MID-CONTINENT AIRPORT 2ND ADDITION
TO WICHITA, SEDGWICK COUNTY, KANSAS

SUB 2000-45 -- One-Step Final Plat of MID CONTINENT AIRPORT SECOND ADDITION

SUB 2000-45 -- One-Step Final Plat of MID CONTINENT AIRPORT SECOND ADDITION

STAFF REPORT
(One-Step Final Plat Approved 6/22/00)

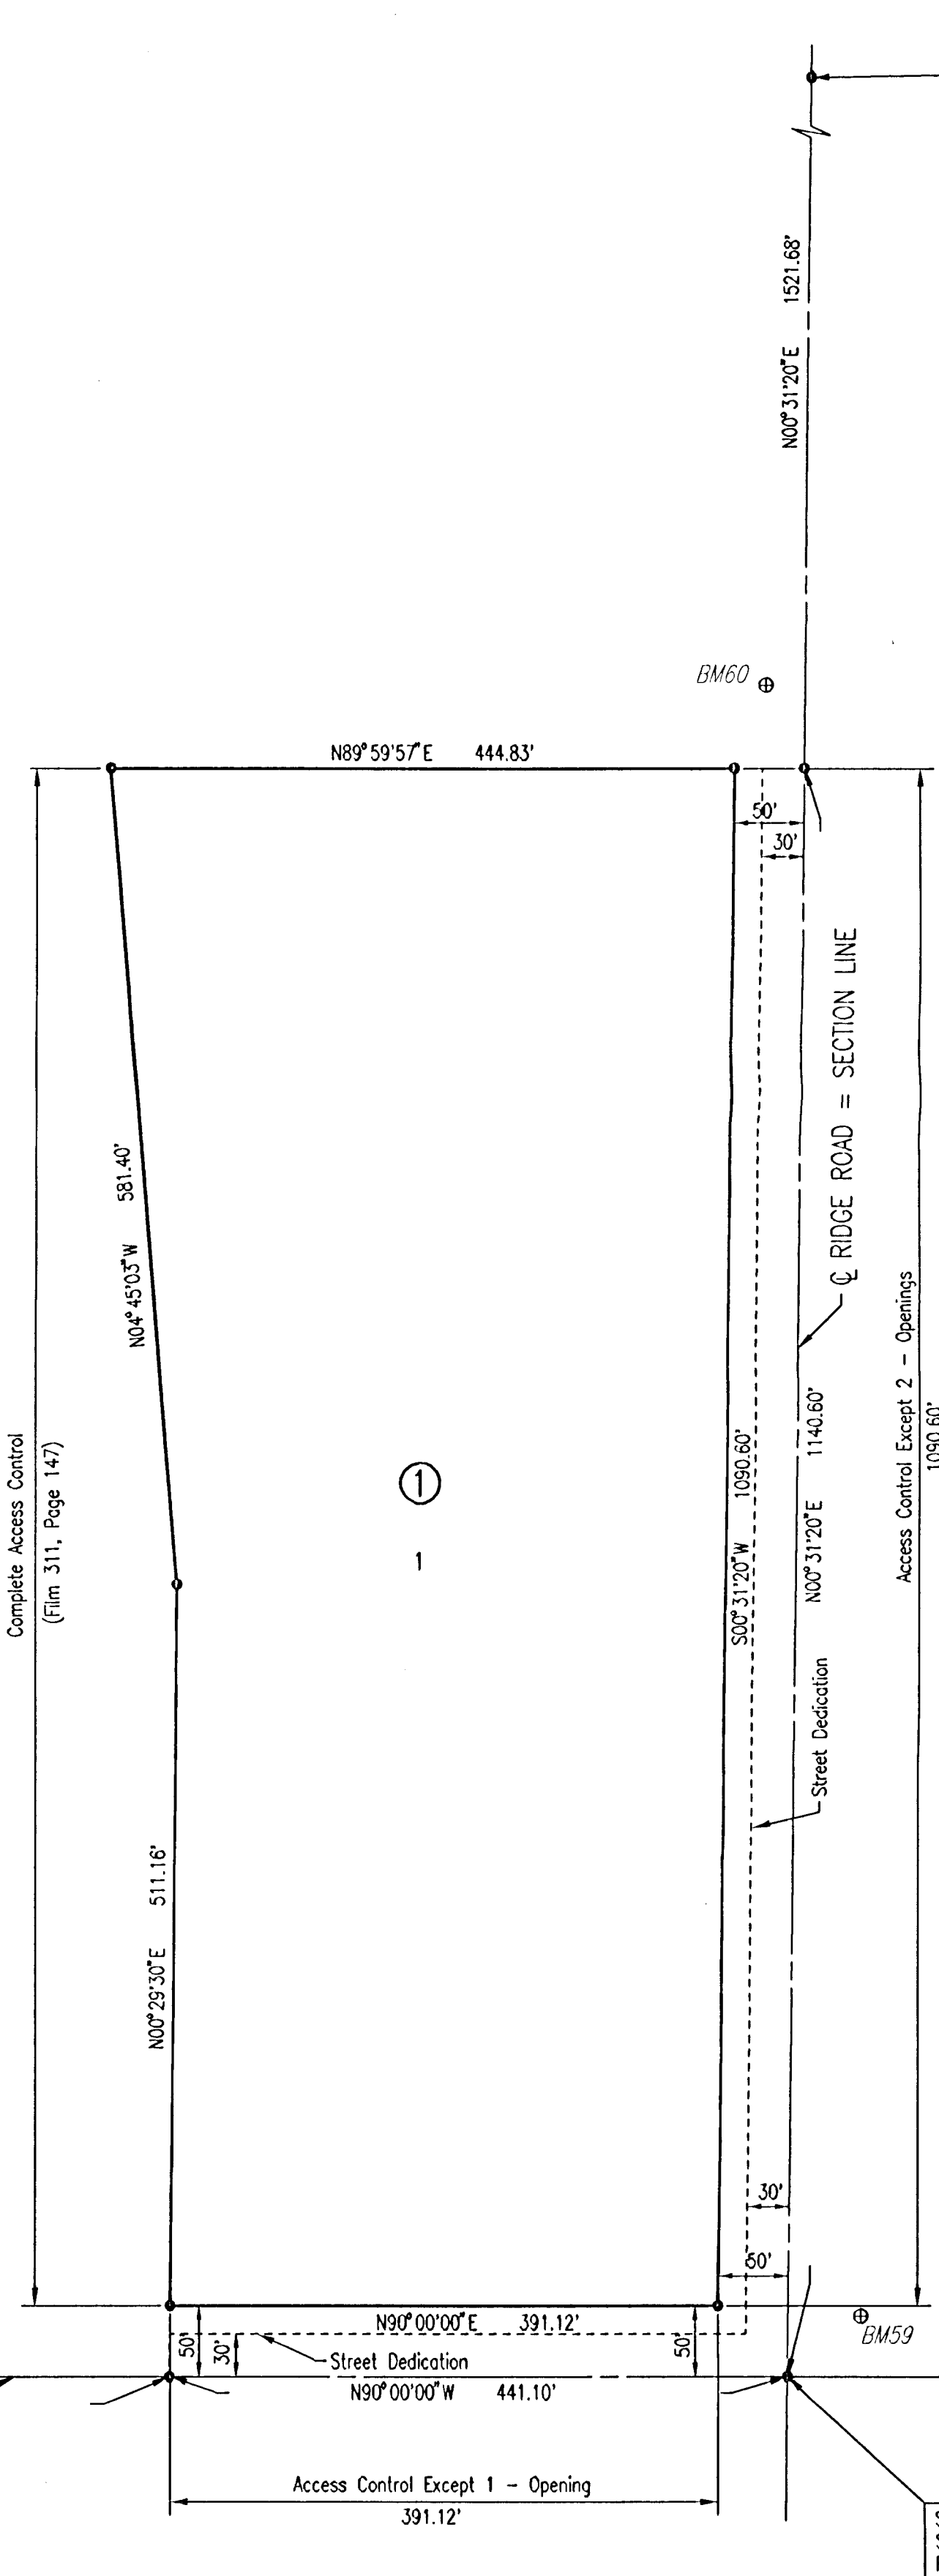
- C. City Engineering needs to comment on the status of the applicant's drainage plan. The drainage plan is approved. A drainage guarantee is required at time of site development.

- D. Traffic Engineering needs to comment on the need for access controls to Harry and Ridge Road. Distances should be shown for all segments of access control. Two points of access are permitted along Ridge Road. One point of access is permitted along Harry.

- F. The platlor's text shall include language that a drainage plan has been developed for the plat and that all drainage easements, rights-of-way, or reserves shall remain at established grades or as modified with the approval of the applicable City or County Engineer, and unobstructed to allow for the conveyance of stormwater.

- L. Perimeter closure computations shall be submitted with the final plat tracing.
- M. Recording of the plat within thirty (30) days after approval by the City Council and/or County Commission.

ALL ABUTTER'S RIGHT OF ACCESS TO AND FROM RIDGE ROAD AND HARRY OVER AND ACROSS THE EAST AND SOUTH LINES OF BLOCK 1 ARE HEREBY GRANTED TO THE CITY OF WICHITA. PROVIDED HOWEVER THAT BLOCK 1 SHALL HAVE ACCESS TO RIDGE ROAD AT TWO LOCATIONS AND ACCESS TO HARRY AT ONE LOCATION AS SHOWN.

A DRAINAGE PLAN HAS BEEN APPROVED FOR THIS PLAT. ALL DRAINAGE EASEMENTS AND RIGHTS-OF-WAY SHALL REMAIN AT ESTABLISHED GRADES AND UNOBSTRUCTED TO ALLOW FOR THE CONVEYANCE OF STORM WATER, UNLESS MODIFIED WITH THE APPROVAL OF THE CITY ENGINEER.
